SERVICE BULLETIN

ENGINE – FUEL AND CONTROL – ENGINE FUEL AND CONTROL – FUEL SYSTEM TUBES – ENGINE –
INTRODUCTION OF A REVISED TUBE ASSEMBLY WITH MATERIAL CHANGE AND REVISED CLIPPING –
CATEGORY CODE 6 – MOD.ENG-73-0102

V2500-ENG-73-0102

Clip point CP1049 - Before and after alteration
Fig. 1

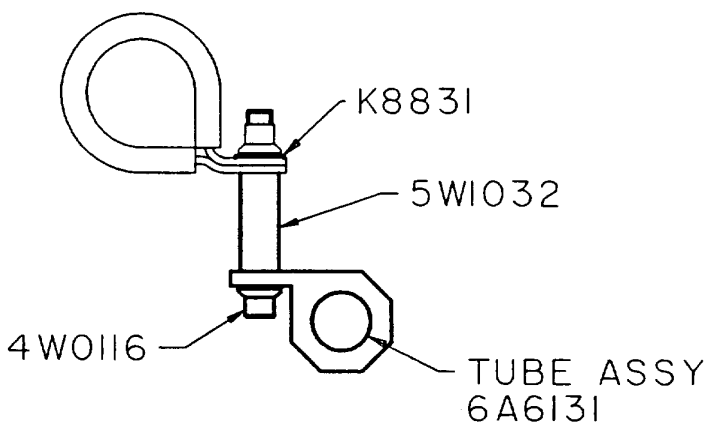
(b) Clip point CP1049 has changed, the changes are as follows:

- (i) The clip that holds the fuel tube assembly is deleted.
- (ii) The length of the bolt has been increased.
- (iii) Another spacer has been added.
